**To:** Planning and Zoning Commission  
**From:** Staff  
**Date:** October 2, 2018  
**Re:** **Case #18018: Lofts at Foxridge Rezoning "R-3A" to "R-3B"**  
**Eagle Glen - Parcel 5**

**To:** Planning and Zoning Commission  
**From:** Staff  
**Date:** October 2, 2018  
**Re:** Case #18019: Lofts at Foxridge Preliminary Plat

**To:** Planning and Zoning Commission  
**From:** Staff  
**Date:** October 2, 2018  
**Re:** Case # 18020: Lofts at Foxridge Final Plat

**To:** Planning and Zoning Commission  
**From:** City Staff  
**Date:** October 2, 2018  
**Re:** Case #18021: Lofts at Foxridge Site Plan

# Proposed Final Plat Drawing:

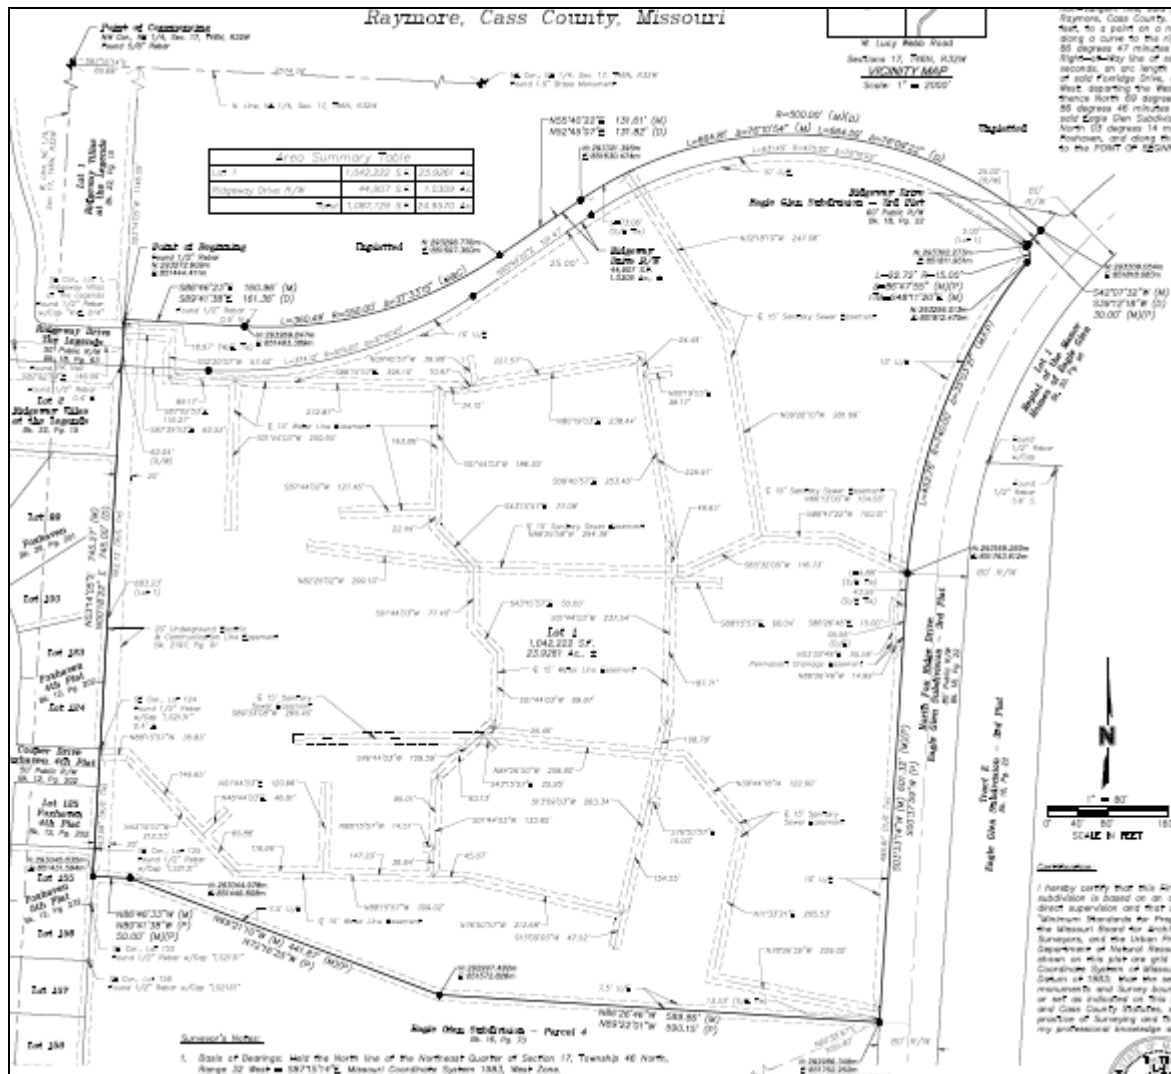
The proposed plat is substantially the same as the proposed preliminary plat. The current plan shows the extension of Cooper Drive through the site. The applicant has submitted a revised preliminary plat which removes this proposed street extension.

5. A sanitary sewer line shall be extended to the southern right-of-way line of Ridgeway Drive. An easement shall be provided for the sewer line. The sanitary sewer line shall be completed with the installation of the public improvements that serve the property.

6. A drainage easement shall be provided for the drainage channel that exists in the northeast corner of the property. The easement shall be added to the final plat drawing.

1. Approval of the final plat is contingent on approval of the proposed preliminary plat for The Lofts at Foxridge.
2. Construction plan drawings of the public improvements shall be submitted to and approved by the Department of Public Works prior to commencement of any utility installation work.
